Carolina Power & Light Company

BRUNSWICK STEAM ELECTRIC PLANT, UNIT NO. 2
DOCKET NO. 50-324/LICENSE NO. DPR-62
REQUEST FOR LICENSE AMENDMENT
TAG NUMBER CHANGE

BRUNSWICK STEAM ELECTRIC PLANT, UNIT 2
NRC DOCKET 50-324
OPERATING LICENSE DPR-62
REQUEST FOR LICENSE AMENDMENT

BASIS FOR CHANGE REQUEST

Figure 1
Existing Configuration

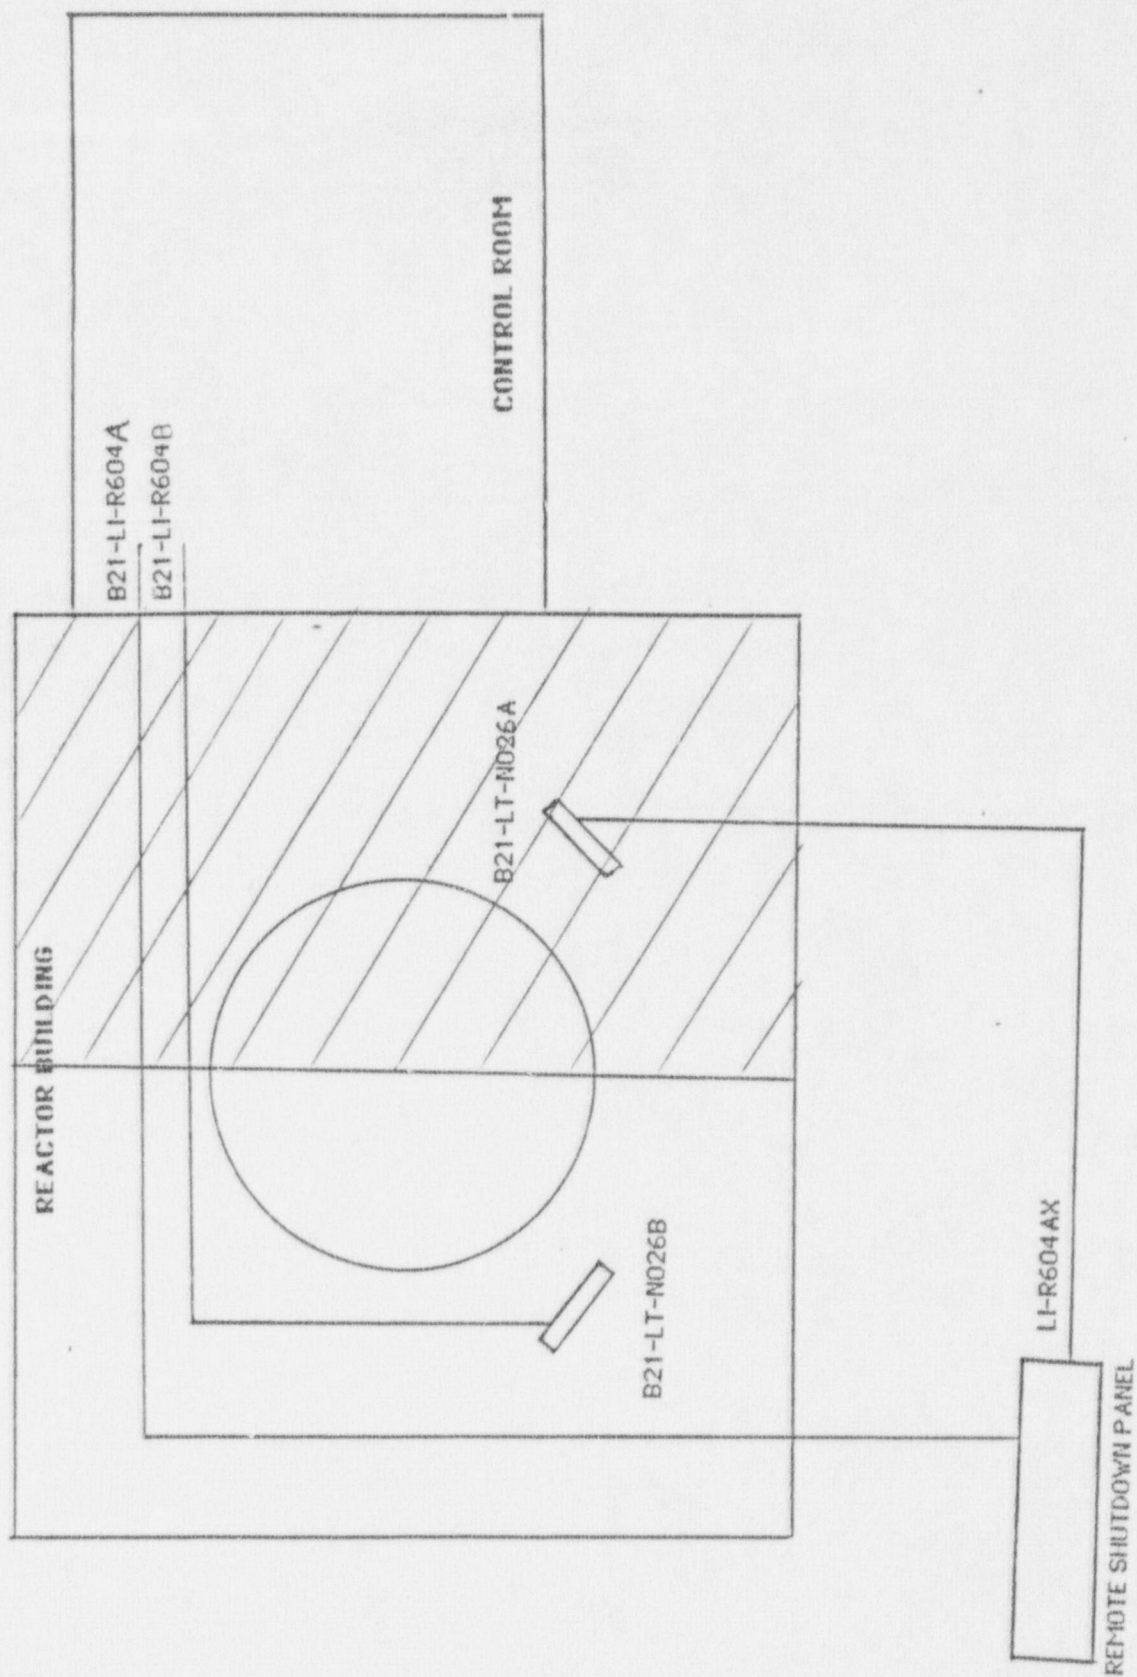
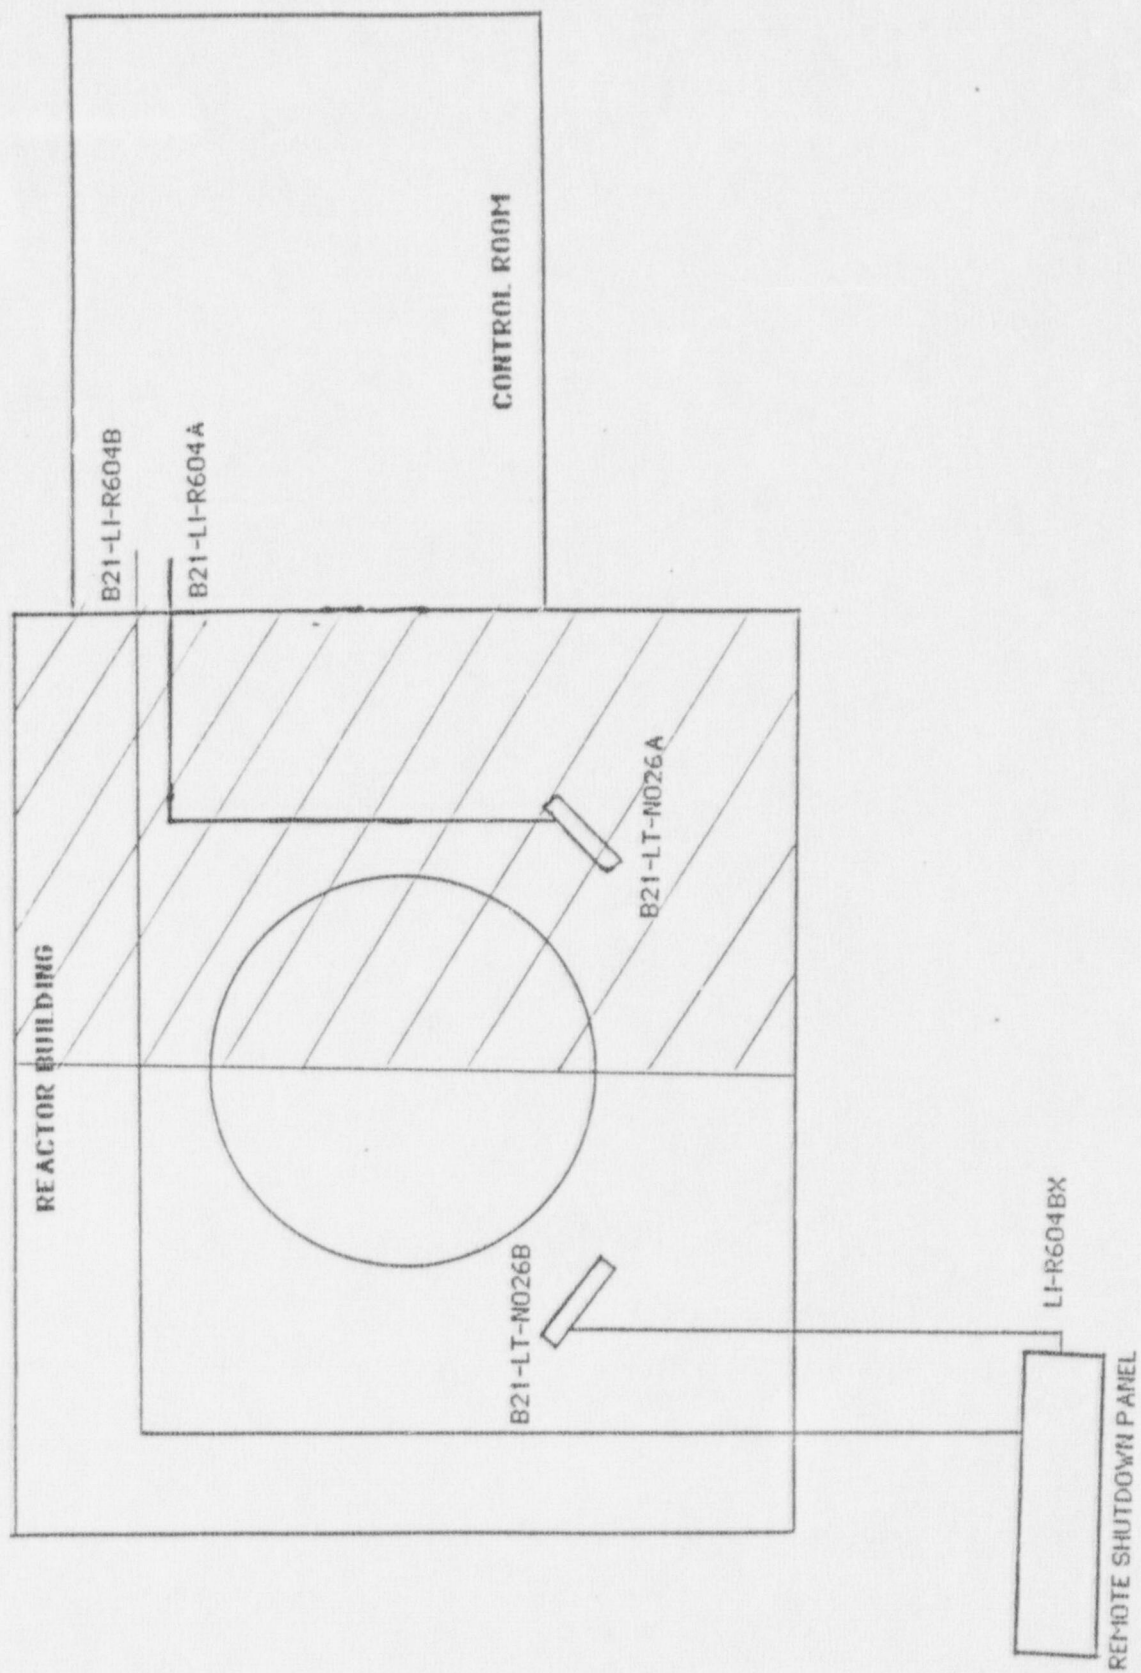
Level transmitter loop B21-LT-N026A currently feeds reactor vessel water level indicator B21-LI-R604AX on the remote shutdown panel, and, via the remote shutdown panel, indicator B21-LI-R604A on the control panel. Level transmitter loop B21-LT-N026B feeds indicator B21-LI-R604B on the control panel (See Figure 1). The proposed change would have transmitter B21-LT-N026B feeding both the control room indicator B21-LI-R604B and the remote shutdown panel indicator B21-LI-R604BX. Level transmitter B21-LT-N026A would feed only indicator B21-LI-R604A in the control room (See Figure 2).

These modifications are being made to address alternate shutdown capability requirements associated with 10CFR50, Appendix R. Currently, in an Appendix R fire in the "North" area of the Reactor Building, indication from these level transmitters on both the remote shutdown panel and in the control room would be lost. The "North" area of the Reactor Building is shown on Figures 1 and 2 with crosshatching. With the current configuration, the instrument rack where transmitter B21-LT-N026A is located would be destroyed in a "North" area fire, as would the cabling from the remote shutdown panel to the control room and from transmitter B21-LT-N026B to the control room. Thus, there would be no level indication from either transmitter in either the control room or on the remote shutdown panel.

Technical Specification Tables 3.3.5.2-1 and 4.3.5.2-1 currently list level indicator B21-LI-R604AX and level transmitter B21-LT-N026A under Item 2, "Reactor Vessel Water Level." The proposed change would replace indicator B21-LI-R604AX with B21-LI-R604BX, and level transmitter B21-LT-N026A with B21-LT-N026B. Thus, level transmitter B21-LT-N026A would provide a vessel level signal to indicator B21-LI-R604A in the control room. Level transmitter B21-LT-N026B would provide a vessel level signal to indicator B21-LI-R604BX on the remote shutdown panel, and, via the remote shutdown panel, indicator B21-LI-R604B in the control room.

With the proposed configuration, a fire in the "North" area of the Reactor Building would only disable indication to the control room, while maintaining indication to the remote shutdown panel. This is acceptable, and would allow the Company to safely shutdown the unit using the Alternate Safe Shutdown Procedures

By rewiring the level instrumentation loops, the Company will be able to safely shutdown the unit using the Alternate Safe Shutdown Procedures. This modification is being implemented to comply with CP&L's commitments to the NRC relating to Appendix R, Section III.G which were submitted to the NRC via the ASCA report in April 1984.
